ADDENDUM NO. 1

Chubbuck Police H.Q. & Animal Shelter
5160 Yellowstone Avenue
Chubbuck, ID 83202

Pre-Bid Request for Information

FUB ASSEMBLY DETAIL

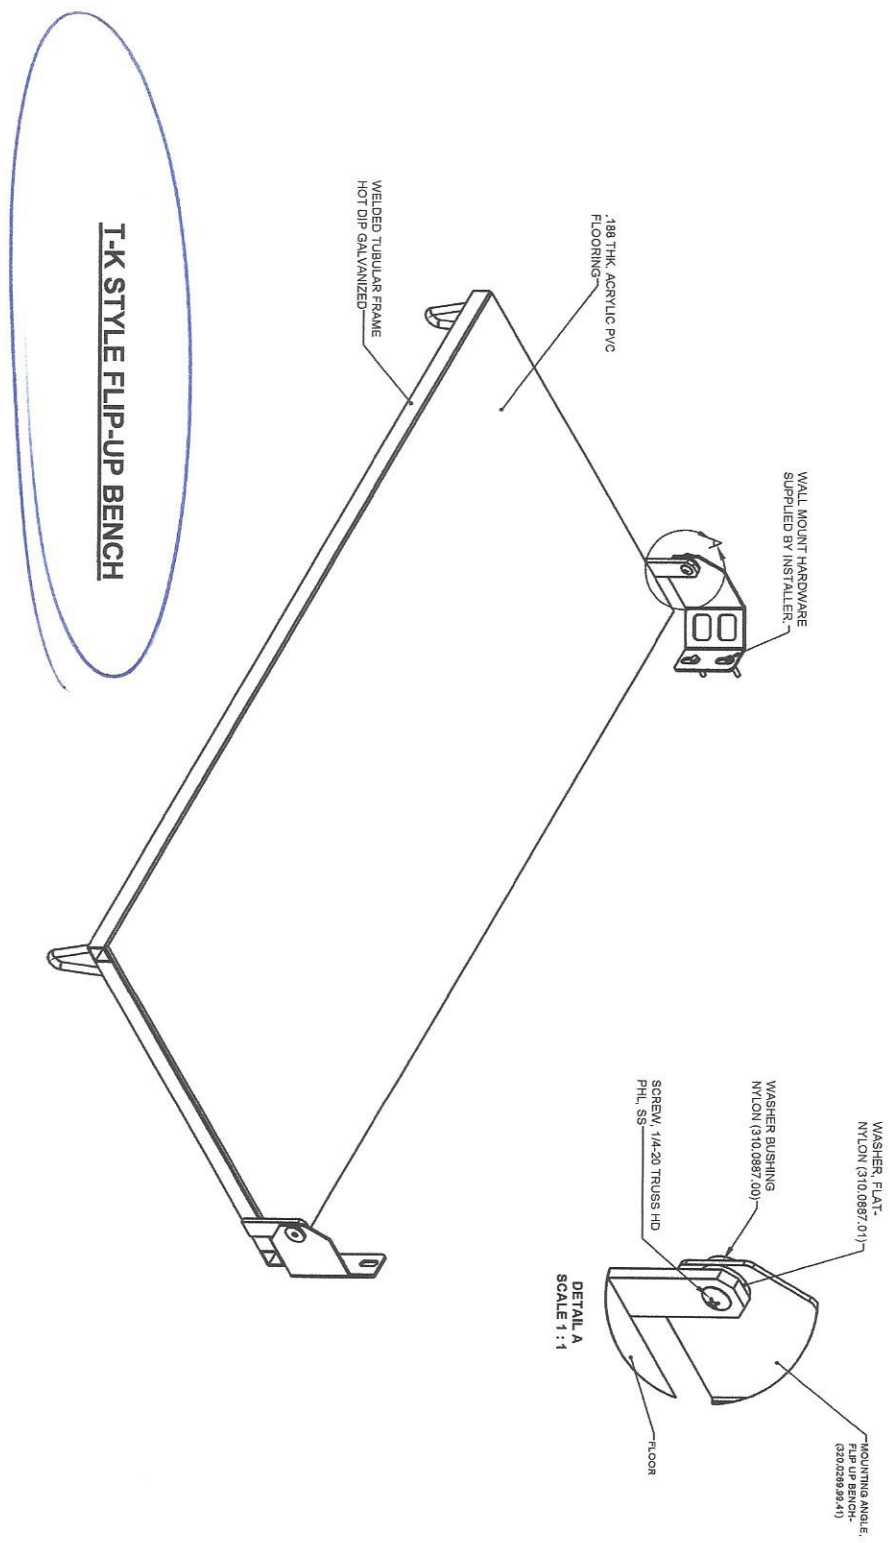
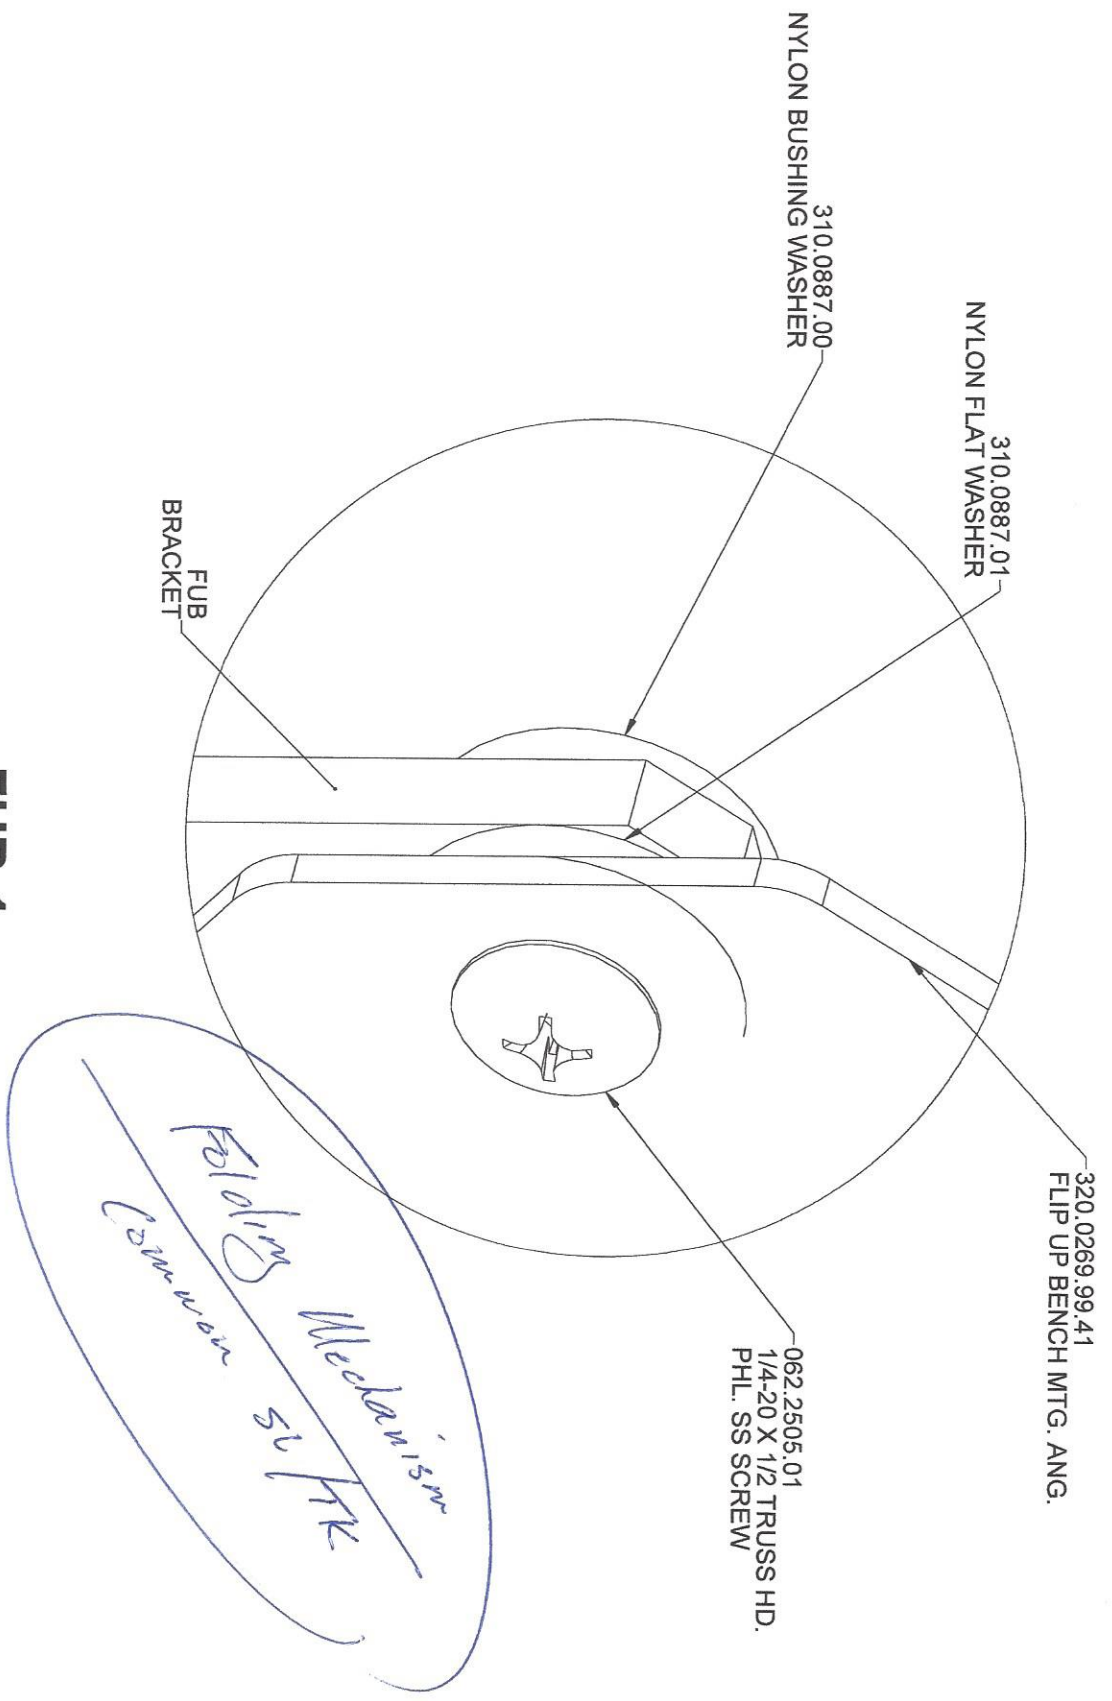
Accessories described are [competitor] Mason Co. Rusty Benches.
Shor-Line Does Not use Aluminum/FRP in any of our
components due to quality and service life issues.

Shor-Line is "Basis of design" for these level components.
Our Fold-up Benches are made of Stainless Steel and Dipped
PVC Steel Benches. See descriptors attached.
Shor-Line and Mason components do not combine.

No resting benches are required. Paragraph 2.3 can be disregarded.
